Office Action Summary	Application No. 10/511,429	Applicant(s) TORRANCE, EDWARD	
	Examiner Hanh V. Tran	Art Unit 3637

DETAILED ACTION

1. This is the Final Office Action from the examiner in charge of this application in response to applicant's amendment dated 10/5/2006.

FIG. 5

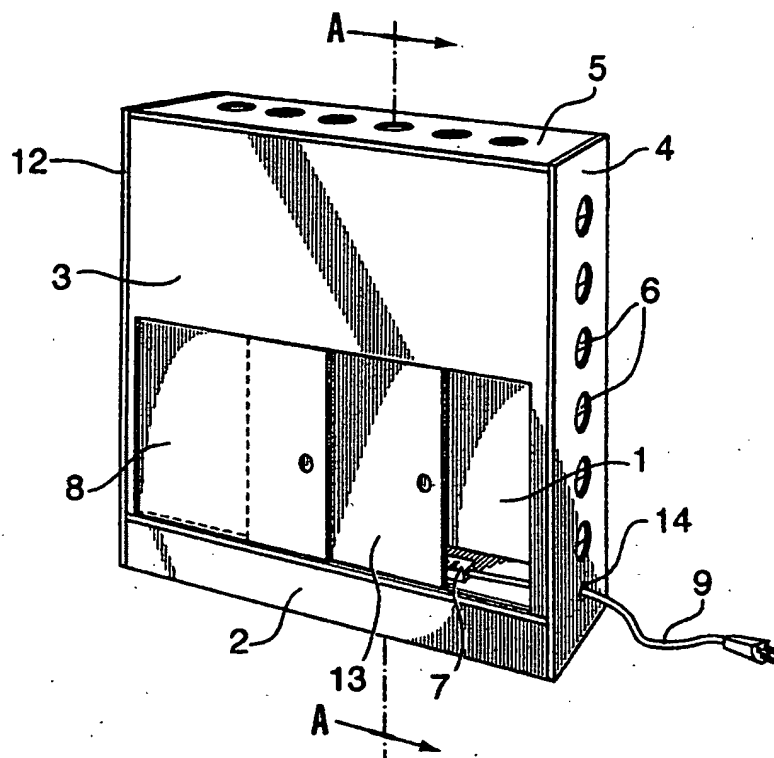
2. The drawings are objected to under 37 CFR 1.83(a). The drawings must show every feature of the invention specified in the claims. Therefore, the limitation in claims 1 and 10 of each closure means having "a fixed portion and a selectively rotatable portion" must be shown or the feature(s) canceled from the claim(s). No new matter should be entered.

3. The drawings are objected to under 37 CFR 1.83(a) because they fail to show element 15 as being an open port and element 16 as being a closed port as described in the specification, page 7, lines 14-18 (Figure 2 shows both elements 15 and 16 as having the exact same configuration.) Any structural detail that is essential for a proper understanding of the disclosed invention should be shown in the drawing. MPEP § 608.02(d). Corrected drawing sheets in compliance with 37 CFR 1.121(d) are required in reply to the Office action to avoid abandonment of the application. Any amended replacement drawing sheet should include all of the figures appearing on the immediate prior version of the sheet, even if only one figure is being amended. The figure or figure number of an amended drawing should not be labeled as "amended." If a drawing figure is to be canceled, the appropriate figure must be removed from the replacement sheet, and where necessary, the remaining figures must be renumbered and appropriate changes made to the brief description of the several views of the drawings for consistency. Additional replacement sheets may be necessary to show the renumbering of the remaining figures. Each drawing sheet submitted after the filing date of an application must be labeled in the top margin as either "Replacement Sheet" or "New Sheet" pursuant to 37 CFR 1.121(d). If the changes are not accepted by the examiner, the applicant will be notified and informed of any required corrective action in the next Office action. The objection to the drawings will not be held in abeyance.

Corrected drawing sheets in compliance with 37 CFR 1.121(d) are required in reply to the Office action to avoid abandonment of the application. Any amended replacement drawing sheet should include all of the figures appearing on the immediate prior version of the sheet, even if only one figure is being amended. The figure or figure number of an amended drawing should not be labeled as "amended." If a drawing figure is to be canceled, the appropriate figure must be removed from the replacement sheet, and where necessary, the remaining figures must be renumbered and appropriate changes made to the brief description of the several views of the drawings for consistency. Additional replacement sheets may be necessary to show the renumbering of the remaining figures. Each drawing sheet submitted after the filing date of an application must be labeled in the top margin as either "Replacement Sheet" or "New Sheet" pursuant to 37 CFR 1.121(d). If the changes are not accepted by the examiner,
